Your Ref: DA0647/2015
Our Ref: D15/3373
DA15110499239 JM

Integrated Development for 522//1168919 - Braemar Street, Tullimbar NSW 2527

PROPOSED RESIDENTIAL SUBDIVISION DA.3	1501 DA.3
LOT 1, 2 & 3 DP 1214606 TULLIMBAR ESTATE	
EASTERN BOUNDARY RETAINING WALL	
CROSS SECTIONS CH0 TO CH100

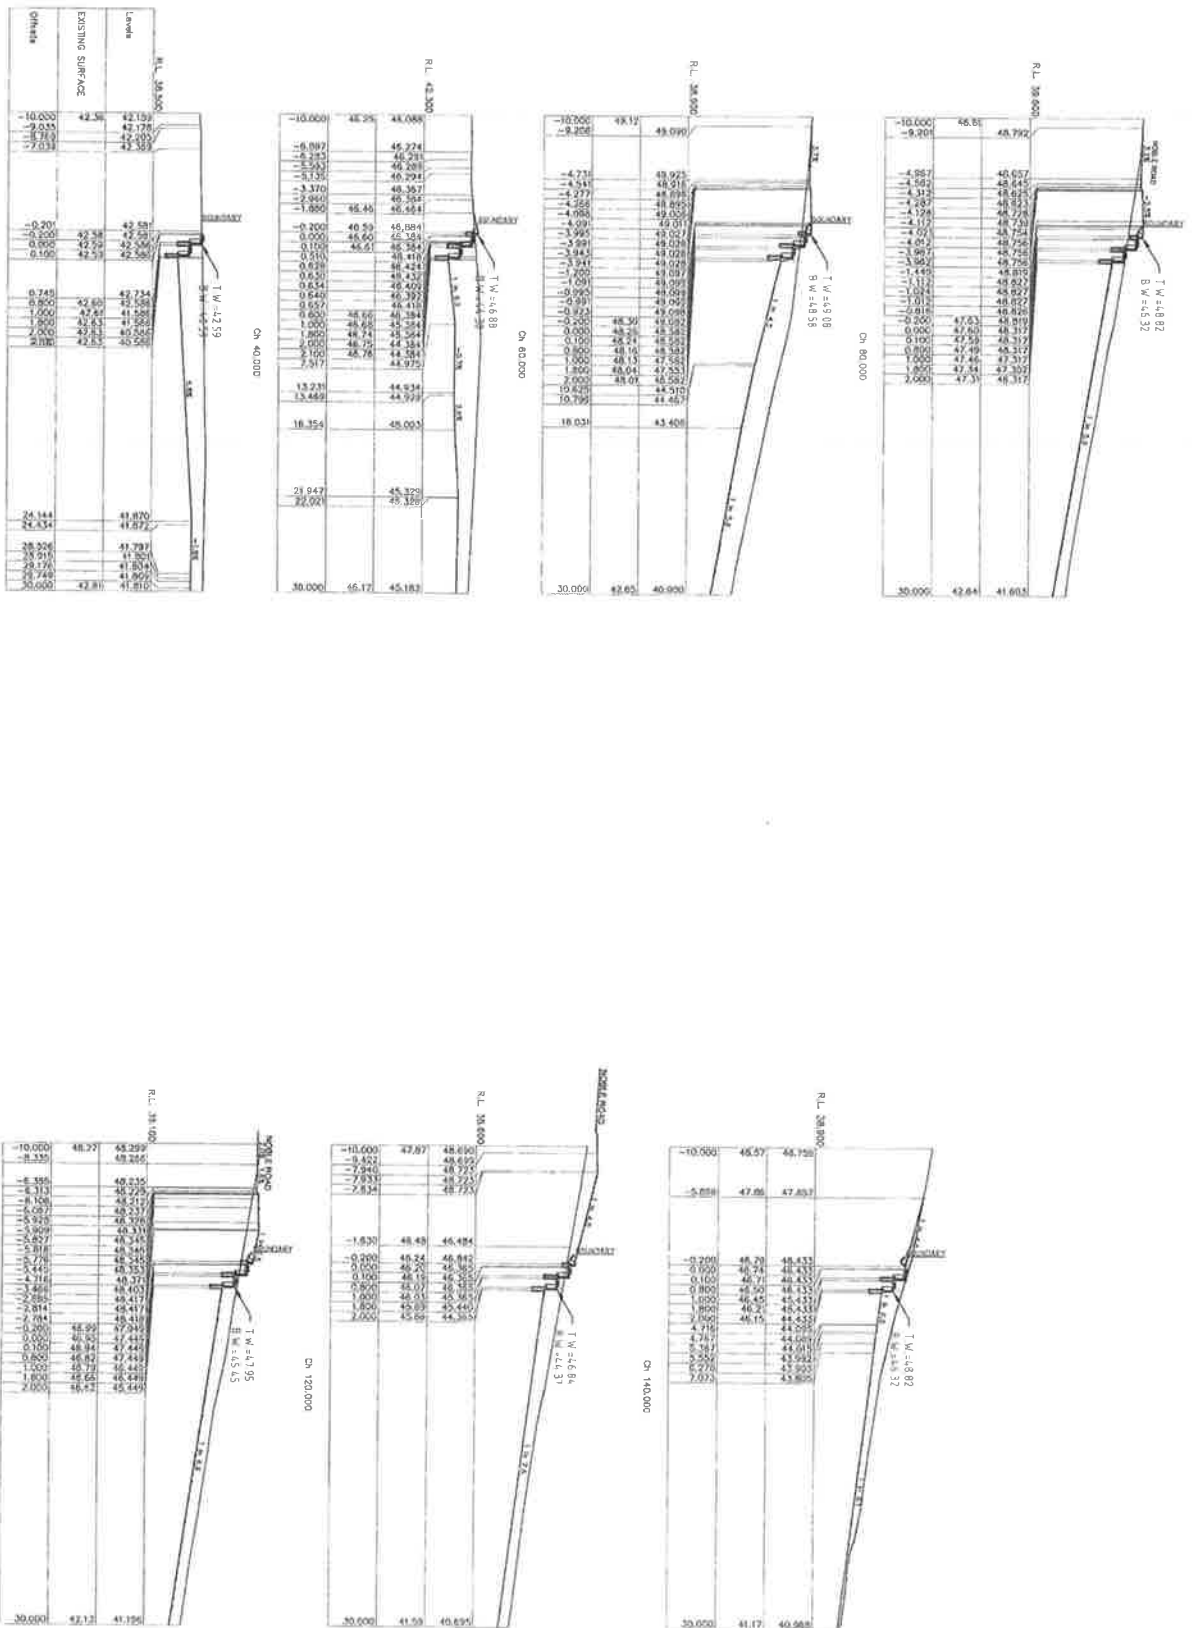
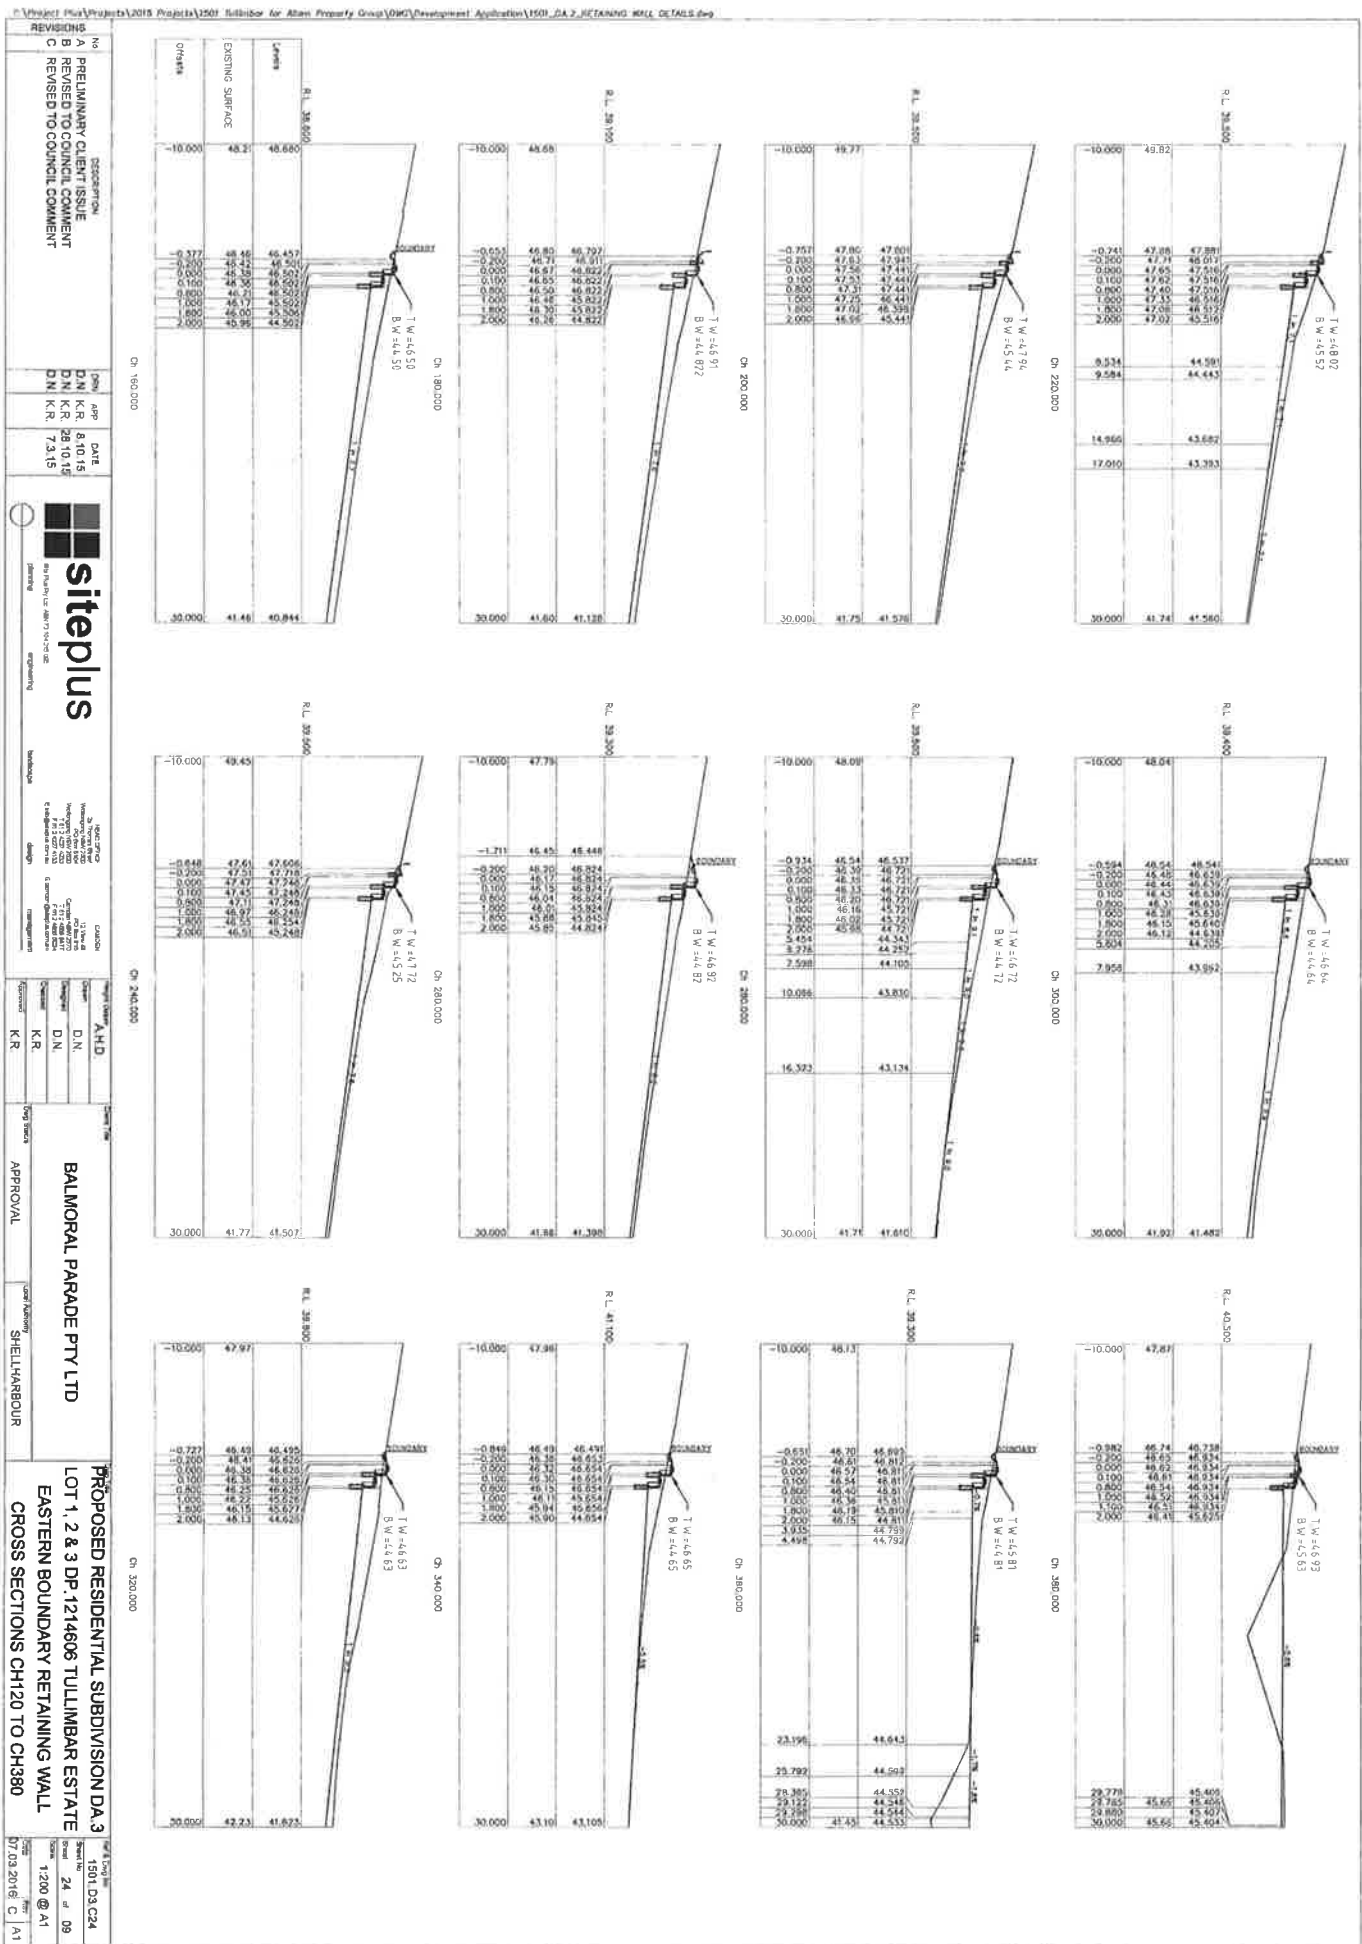
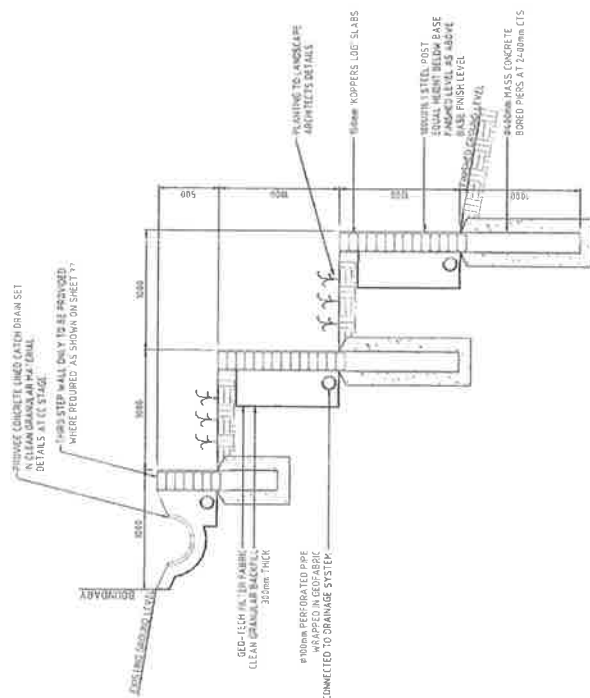
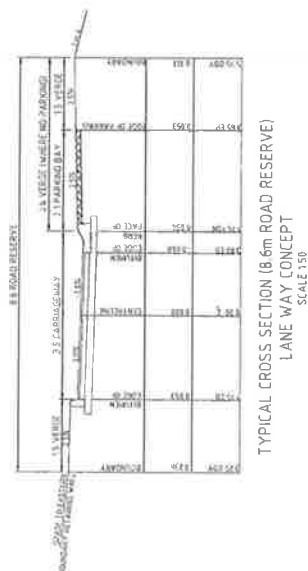
Substantial cut is proposed along the western side of a proposed catch drain. The civil works plans indicate that this cut will be stabilised with a 1.8m – 2.4m high retaining wall within the properties of proposed lots 230-234, 344, 316-322. The retaining wall will continue along the northern boundary of lot 230. The SDCP however refers to a maximum retaining wall height of 1m. The SEE does not appear to address this policy requirement nor provide a justification for the proposed depth of cut.

- a. Subdivision layout plans should include retaining wall location and heights.
- b. Cross sections through lot #37–#230, Noble Road–#233, adjoining land with structure (eg no. 6) to an adjoining lot where no earthworks are proposed (eg #315) that details existing and proposed site levels, TOW heights, interface of retaining walls with adjoining lands. A cross section where the wall is highest should be selected.
